ELP at Rock Spring, Forest Conservation Plan H-135

Summary

Preliminary Forest Conservation Plan (PFCP)

50 SCALE PLAN

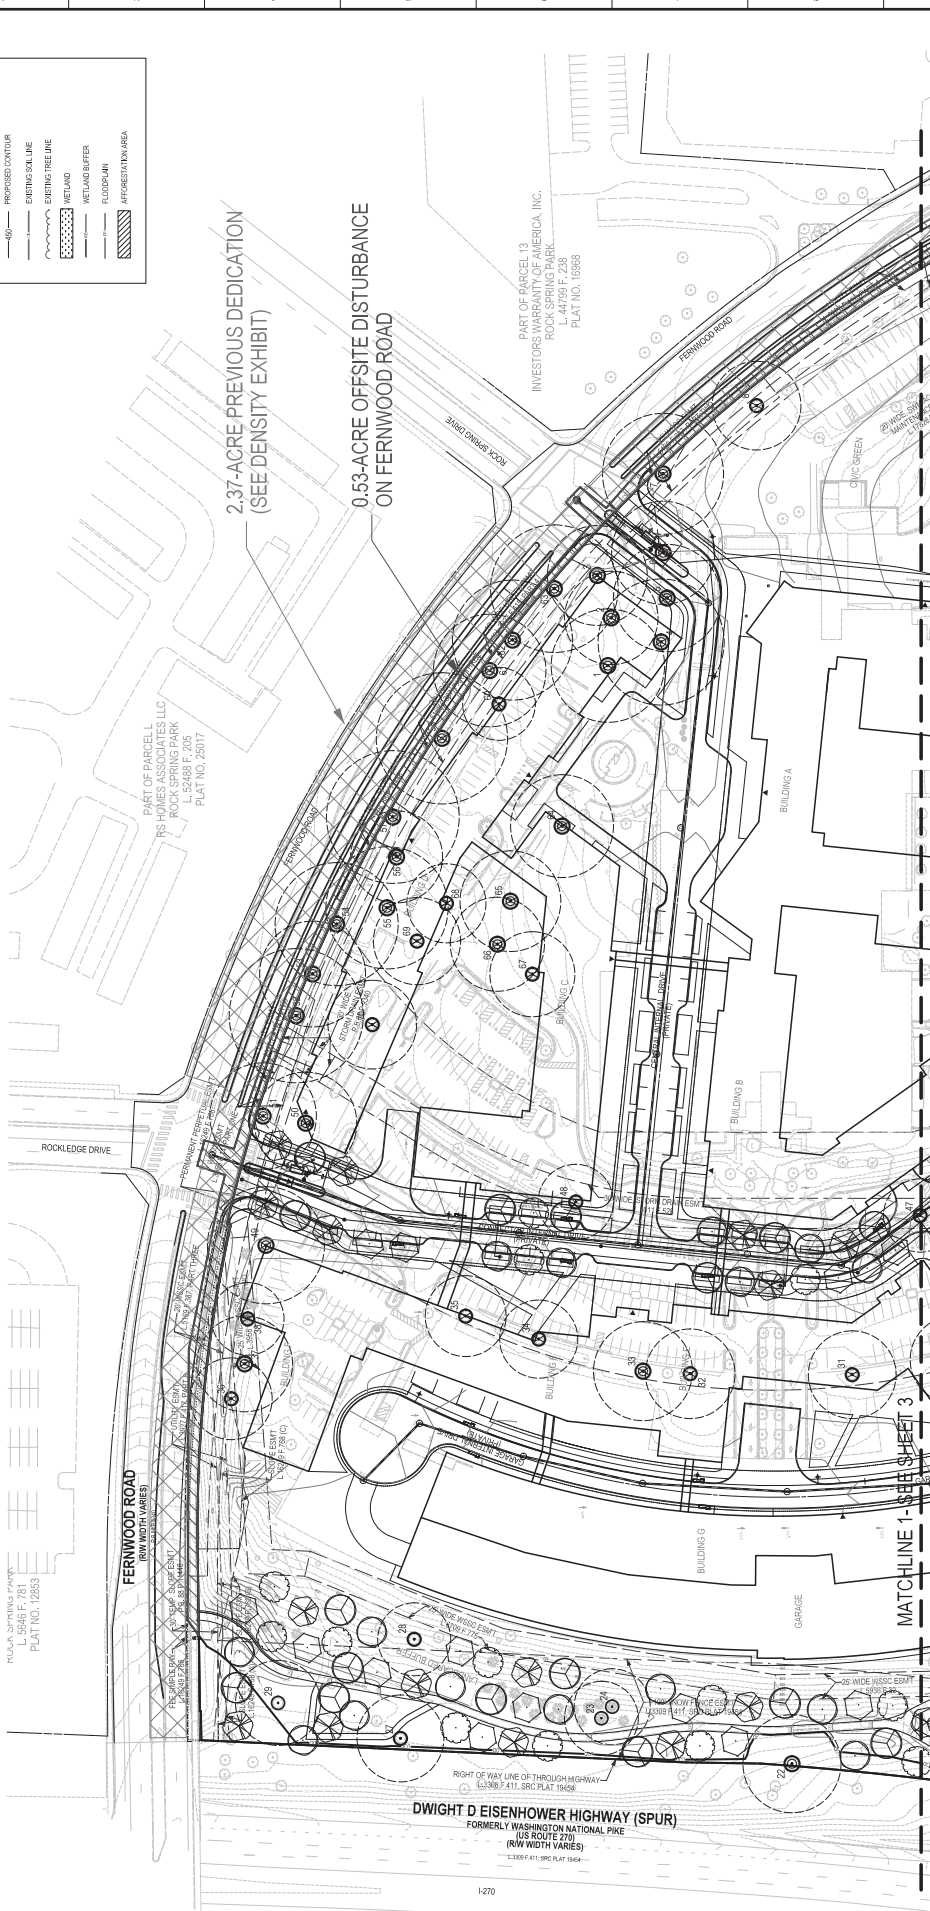
At this time, Staff recommends that the variance to impact and remove trees number 15, 16, 17, and 18 be granted because they are within the area where the southern access road must be relocated out of the stream buffer (Table 1).

Staff cannot recommend approval to impact or remove the other 31 trees at this stage of the development review process, as requested by the Applicant, due to the conceptual nature of the Floating Zone Plan. The Applicant must submit a revised variance request at the time of Site Plan review/Final Forest Conservation Plan to justify impacts to, and/or removal of, the remaining variance trees. Staff's justification for this requirement is based on the following:

Variance trees number 3, 7, 37, 49, 51, 52, 53, 54, 55, 56, 57, 58, 61, 62, and 63 lie along the Property frontage abutting Fernwood Road and Westlake Terrace. Frontage improvements may impact these trees. However, the Design Guidelines for Rock Spring recommend a road diet along this stretch, which would negate the need to move the curb or do significant disturbance near these trees. Portions of the existing sidewalk are already the recommended width, and it might be possible to employ tree save measures and use context-sensitive materials, such as one of the flexible paving products, that would enable some or all of these trees to be saved. Therefore, Staff cannot determine definitively at this time that these trees must be impacted or removed. The disposition of these trees should be reevaluated at Site Plan.

Variance trees number 4, 5, and 6 are shown as being impacted by a utility line tie-in to a connection in Fernwood Road. However, it might be possible to adjust the alignment of this utility line in later iterations of the plan, so Staff cannot determine definitively at this time that these trees must be impacted or removed. The disposition of these trees should be reevaluated at Site Plan.

Variance trees number 1, 2, 19, 20, 33, 50, 64, 65, and 66 are interior to the Property, and may be impacted by building footprints and/or circulation connections. However, these elements are conceptual at this stage of the review. Later iterations of the plan may change these development elements, and open opportunities to preserve some of these trees in open space areas interior to the

Tree number 21 lies in the stream valley on the south of the Property. The LOD is shown as intersecting the Critical Root Zone (CRZ) of this tree, but the proposed asphalt path alignment is not within this CRZ, and it does not appear to be in an area where existing pavement must be removed. Therefore, Staff cannot support justification for impacting the tree at this time.

Tree number 22 is along the western side of the Property. An asphalt path is shown crossing the edge of this tree's CRZ. However, it may be possible to adjust the alignment of the path to avoid the impact. Therefore, Staff cannot support justification for impacting the tree at this time.

Trees number 12 and 13 are in the stream buffer on the eastern side of the Property near Fernwood Road. They do not appear to be impacted by the proposed LOD. Therefore, no variance approval is required at this time.

2. The Final Forest Conservation Plan must:
 - a. be consistent with the approved PFCP;
 - b. show the planting locations of at least 36.1 total inches caliper of native shade trees, each at least three inches caliper, to mitigate the removal of variance trees number 15, 16, 17, and 18;

- d. include a new variance request to determine the disposition of the remaining variance trees
3. The Limits of Disturbance (LOD) on the FFCP must be consistent with the LOD on the Sediment and Erosion Control Plan.

11. No clearing, grading, or any demolition may occur prior to receiving approval of the FFCP and satisfying any off-site planting requirements.
12. The Applicant must amend the PFCP prior to certification to reflect the variance approval for only trees number 15, 16, 17 and 18.
